Access Compliance Report

Public Rights-of-Way

(Curb Ramps)

Intersection ID: 49382	Main Street: SOUTH_DEVON_ST	Cross Street: ROCKY_RIVER_RD	Location: SE
ADA ID: 11819645D025	Ramp Type: Perp	Initial Pass/Fail: Fail	Overall Compliance: No
Severity Score: 8.75			
Codes/Mitigation Info/Possible Solution		Field Measurements/Component Compliance

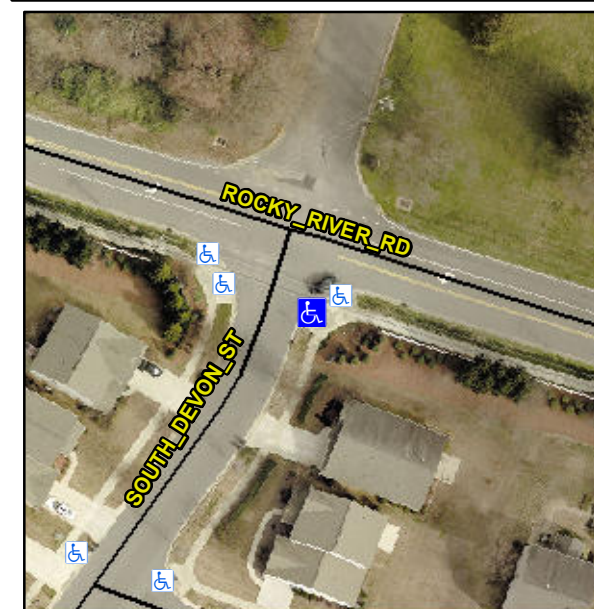
Not Found, R304.5.1

Compliance	Description	Data	Compliance	Description	Data
N/A	Ramp Length (in)	101.5	Yes	Ramp Slope (%)	6.0
No	Ramp Width (in)	47.0	Yes	Ramp XSlope (%)	0.6
N/A	Flare Type LT	N/A	N/A	Flare Type RT	N/A
N/A	Flare Slope LT (%)	N/A	N/A	Flare Slope RT (%)	N/A
N/A	Flare Traversable LT?	N/A	N/A	Flare Traversable RT?	N/A
N/A	Landing Length (in)	N/A	N/A	DWS Provided?	N/A
N/A	Landing Width (in)	N/A	N/A	DWS Contrast?	N/A
N/A	Landing Slope (%)	N/A	N/A	DWS Length (in)	N/A
N/A	Landing X Slope (%)	N/A	N/A	DWS Full Width?	N/A
N/A	Landing Curb? (Y/N)	N/A	N/A	DWS Offset (in)	N/A
N/A	Shared Landing?	N/A			
N/A	Gutter Ponding?	N/A	N/A	Gutter Slope (%)	N/A
N/A	Gutter Lip Ht (in)	N/A	N/A	Gutter X Slope (%)	N/A
N/A	Painted X Walk1?	No	N/A	Painted X Walk2?	N/A
	X Walk 1 Direction	To NW		X Walk 2 Direction	N/A
N/A	X Walk 1 Width (in)	N/A	N/A	X Walk 2 Width (in)	N/A
	X Walk 1 Slope (%)	0.6		X Walk 2 Slope (%)	N/A
	X Walk 1 X Slope (%)	0.6		X Walk 2 X Slope (%)	N/A

Remove & Replace Entire Ramp.
